# 42 HONEYSUCKLE DRIVE COTTAGE CREEK PRECINCT NEWCASTLE

STATE SIGNIFICANT DEVELOPMENT (SSD-10378)  
DEVELOPMENT MODIFICATION 2

ARCHITECTURAL DESIGN STATEMENT

NOVEMBER 2021

# 9.1 DESIGN CHANGES EAST ELEVATION

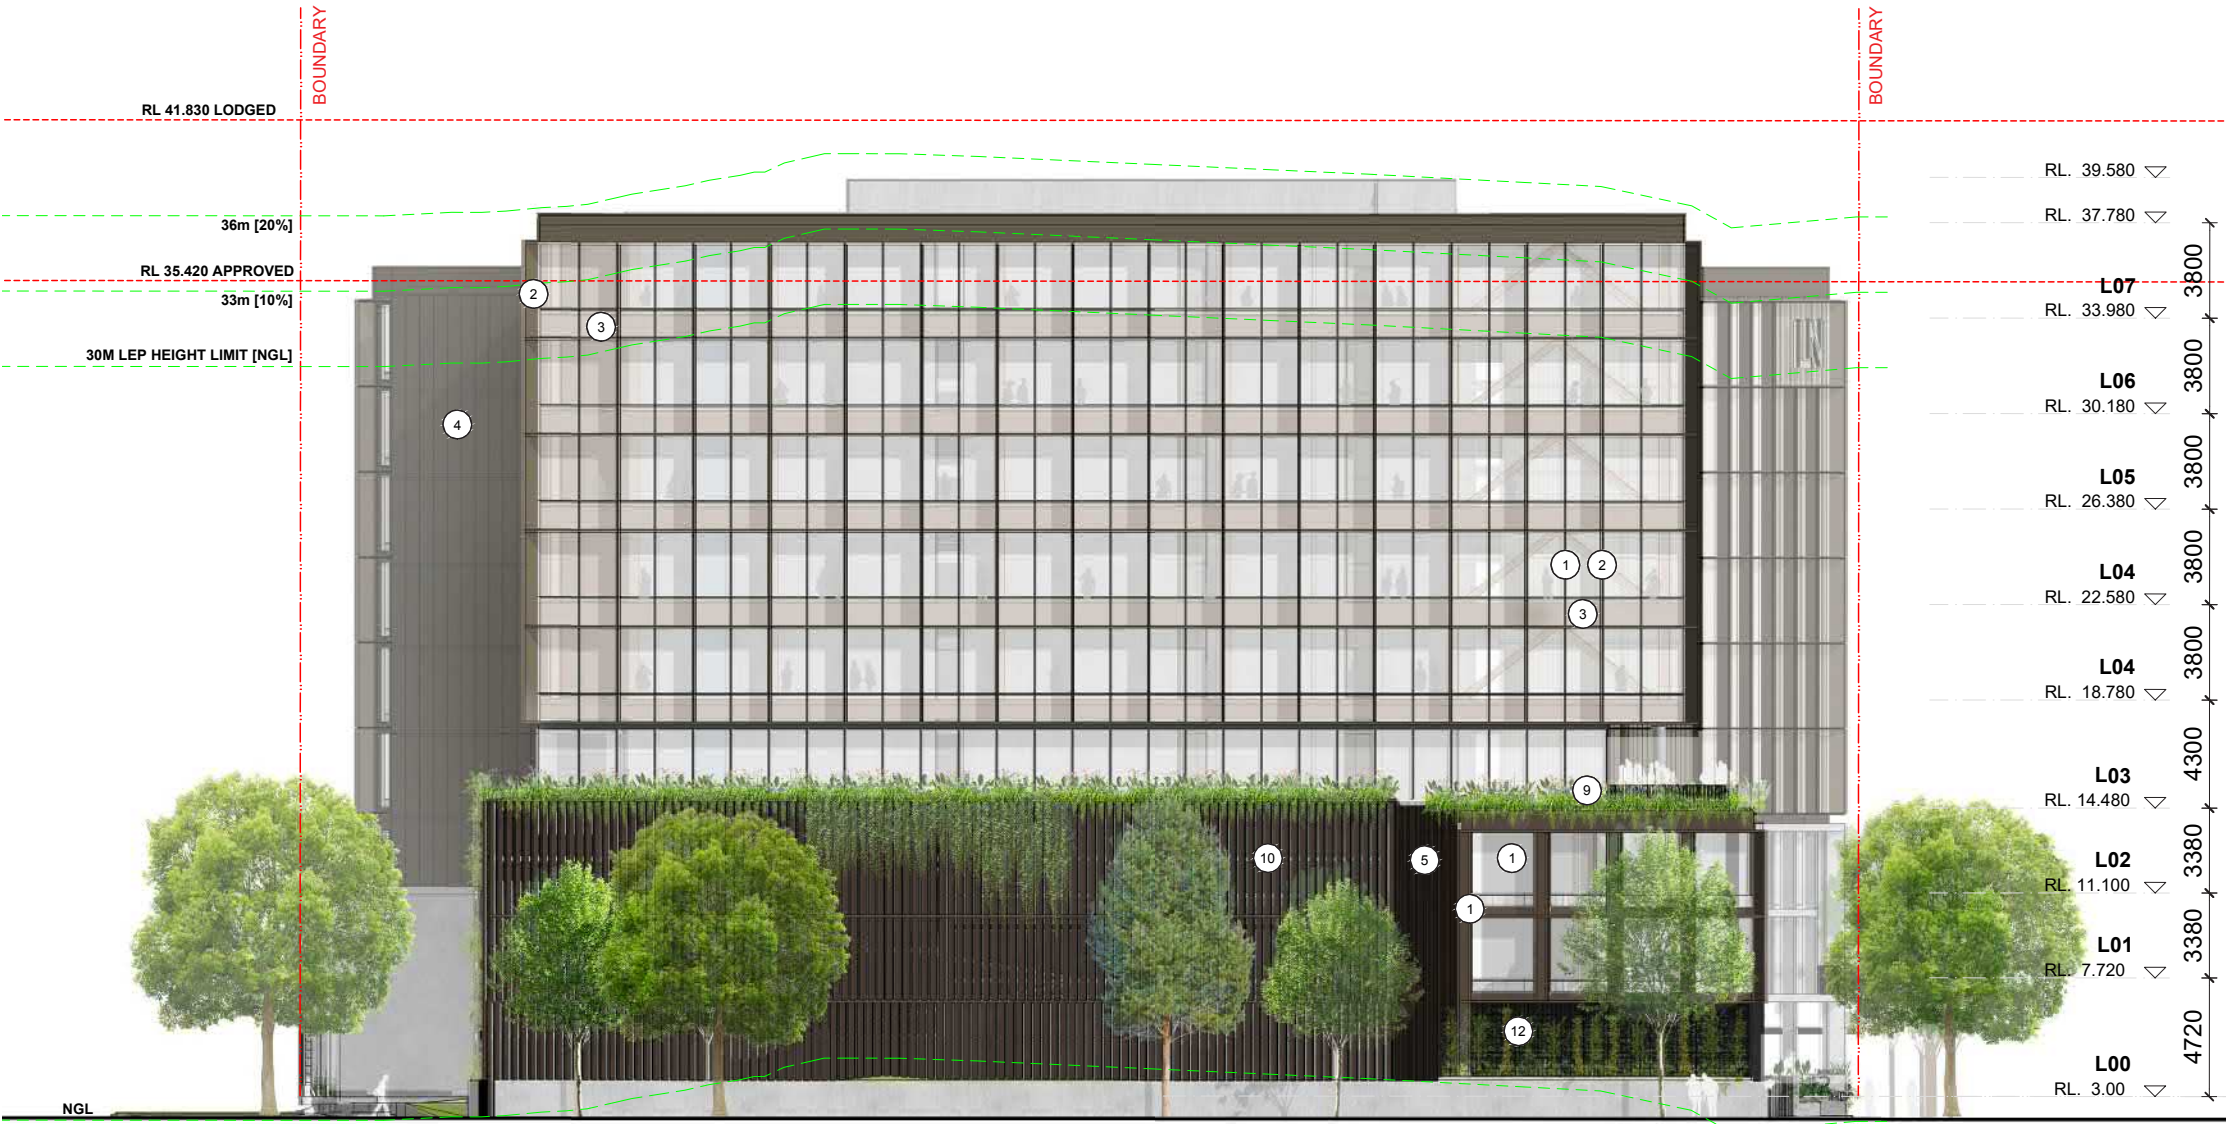
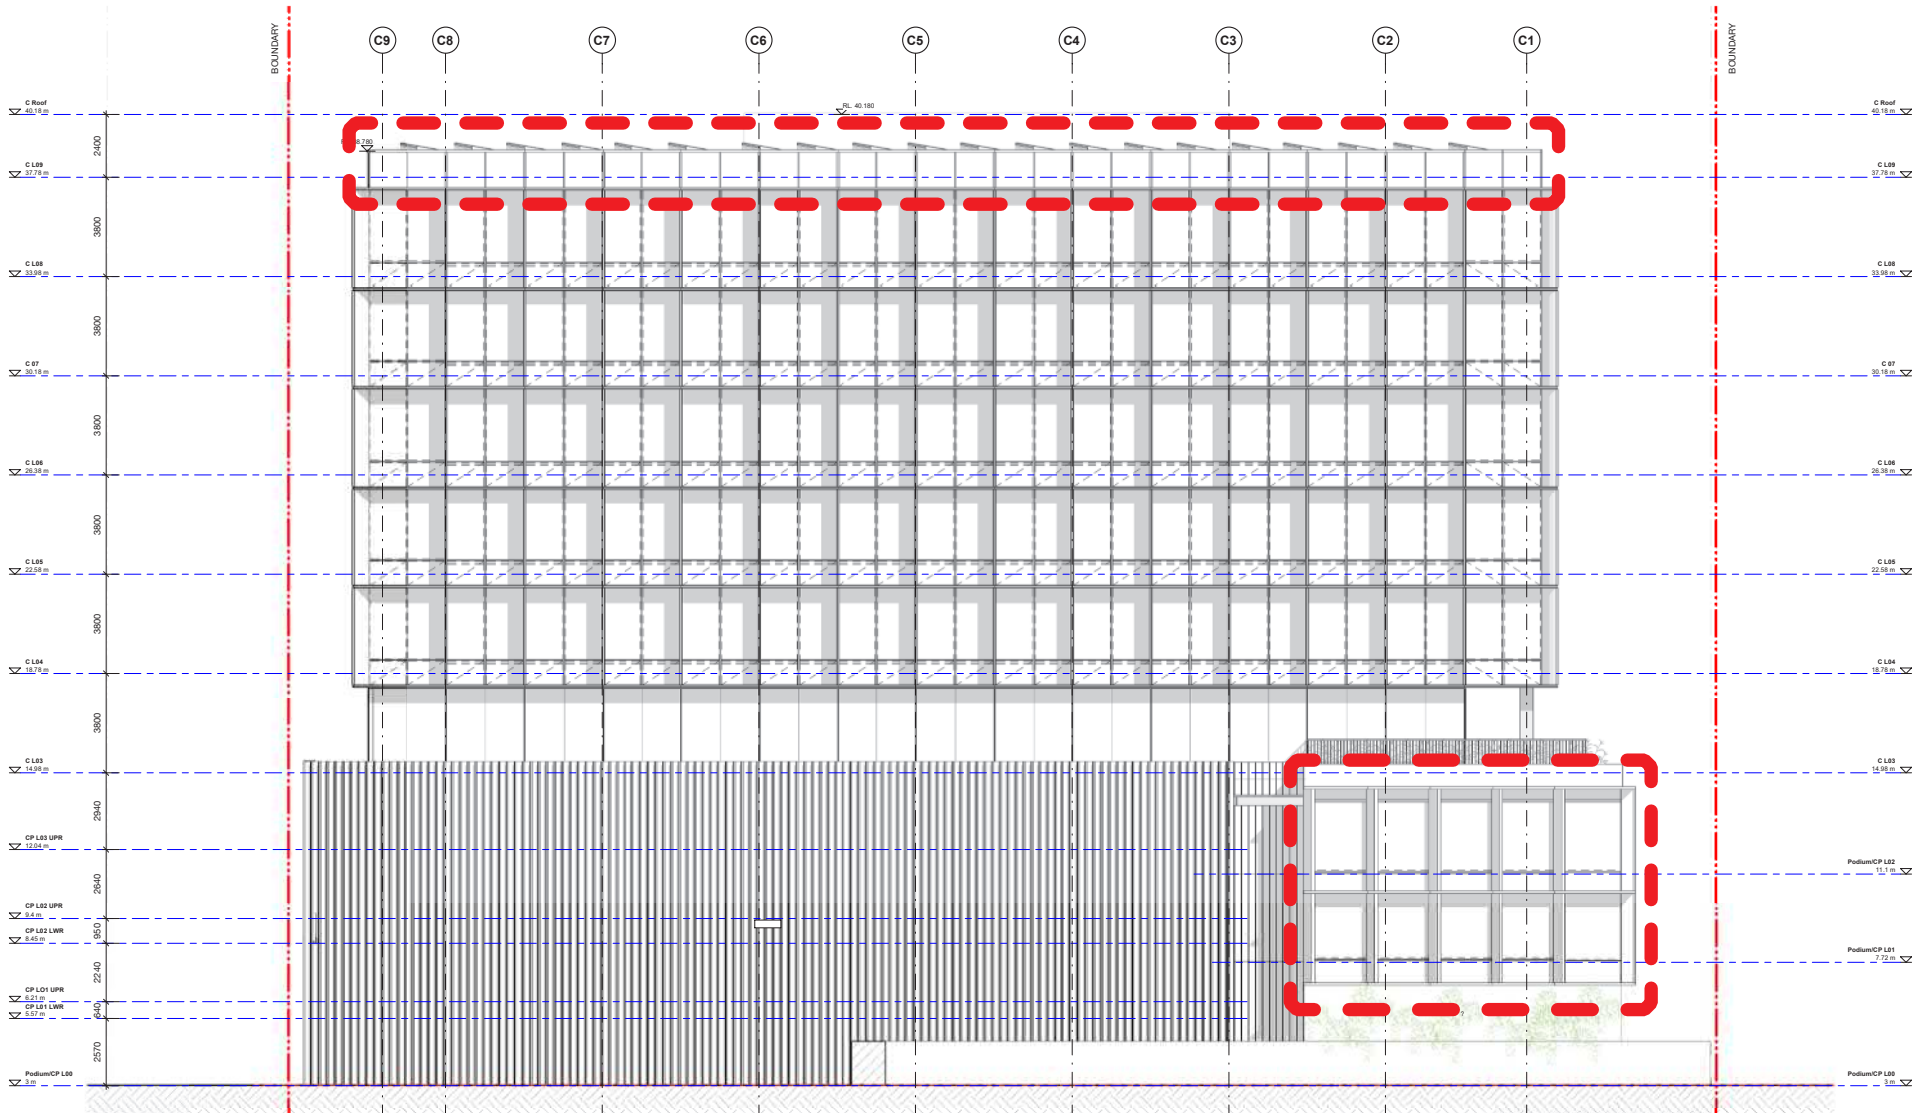
- 1 / Commercial podium levels L01 and L02 facade amended with a singular vertical sunshade expression
- 2 / Commercial tower height increased by 600mm to allow for additional plant height.
- 3 / Perimeter edge planters to Level L03 omitted

# 10.1

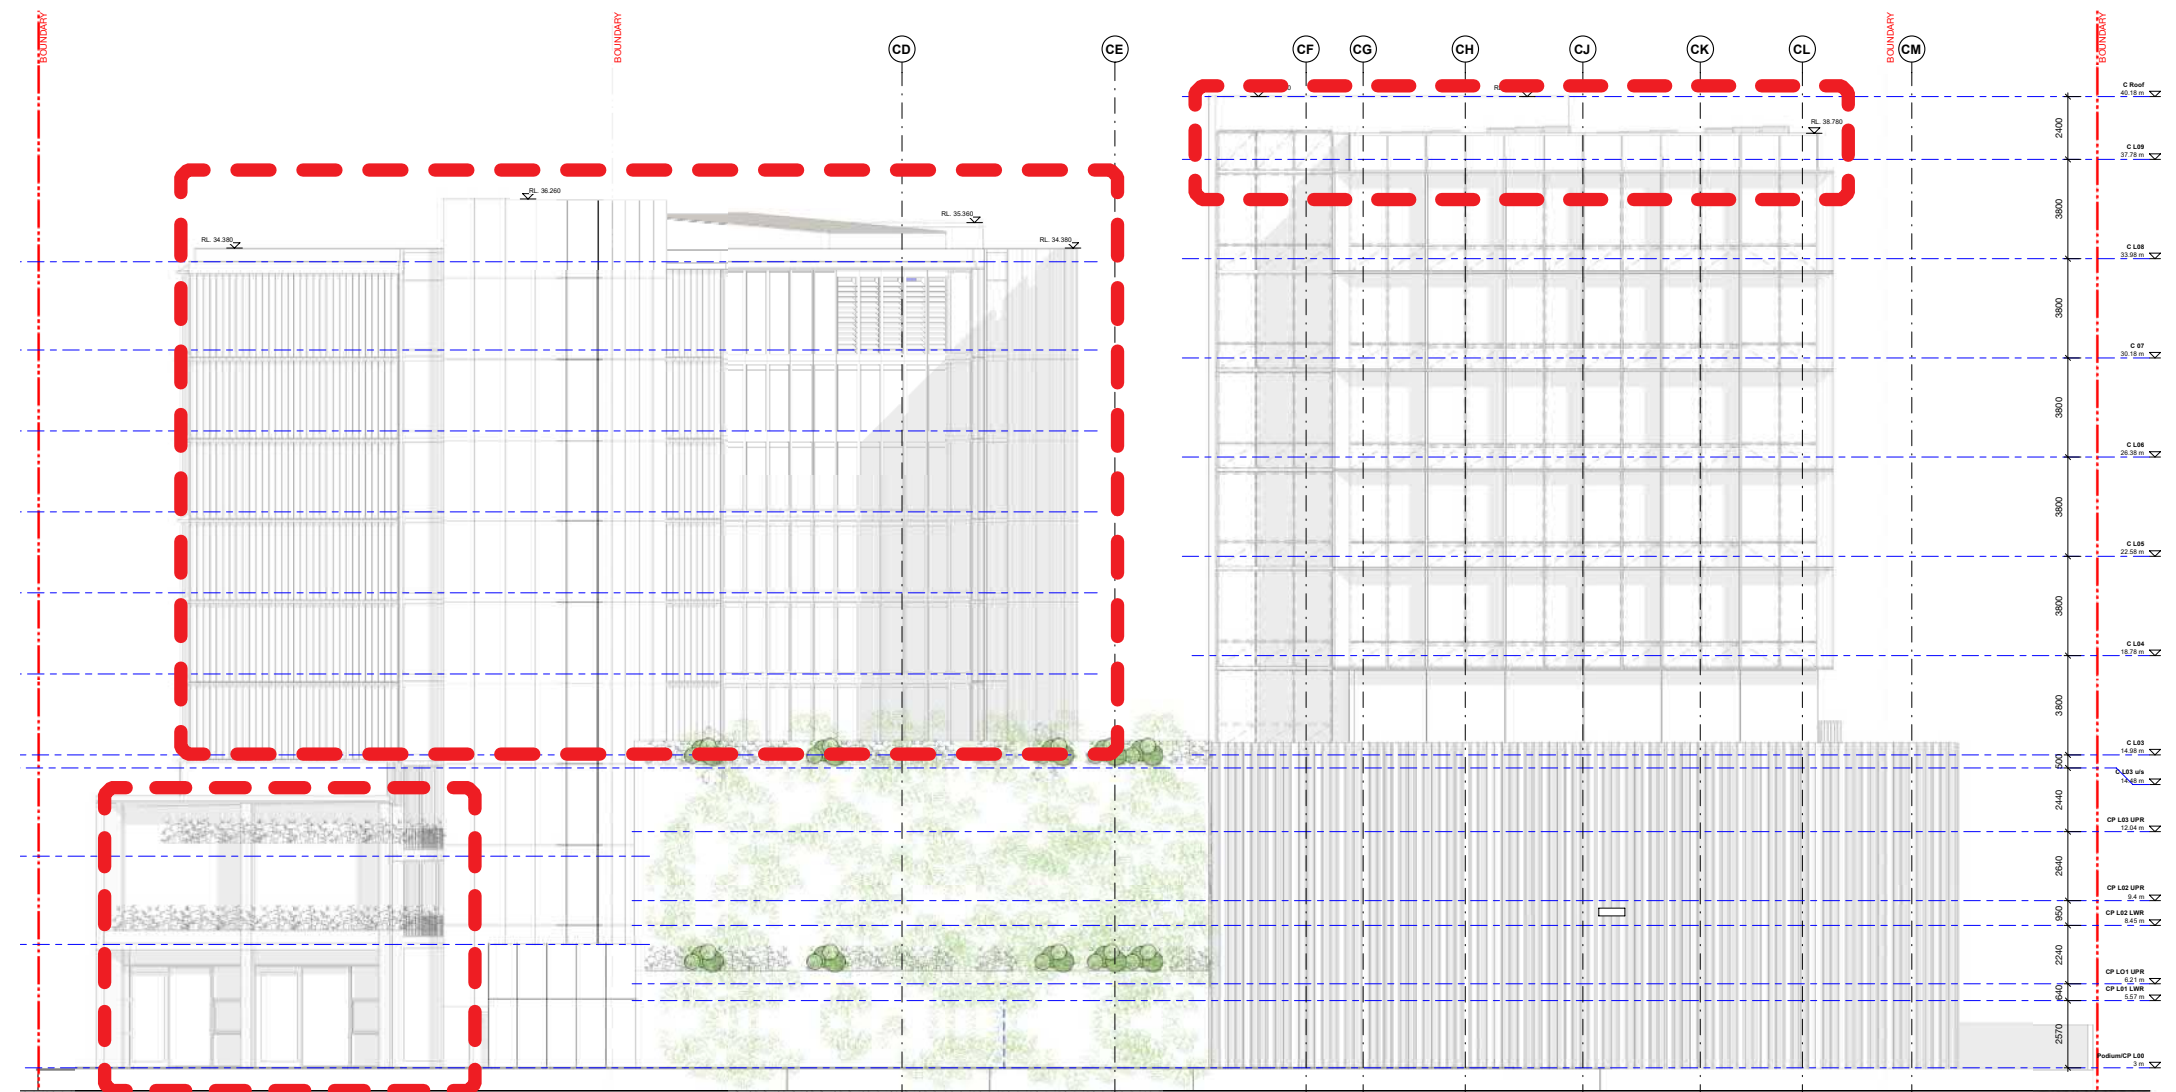
1 / Commercial tower height increased by 600mm to allow for additional plant height.

2 / Perimeter edge planters to Level L03 omitted

3 / Hotel slab to slab levels reduced from 3380mm down to 3100mm. This has resulted in an overall hotel building height reduction.

4 / Hotel south end of building has been reduce in length by 1 hotel room width.

5 / Arbor structure has been pulled back at the south boundary.
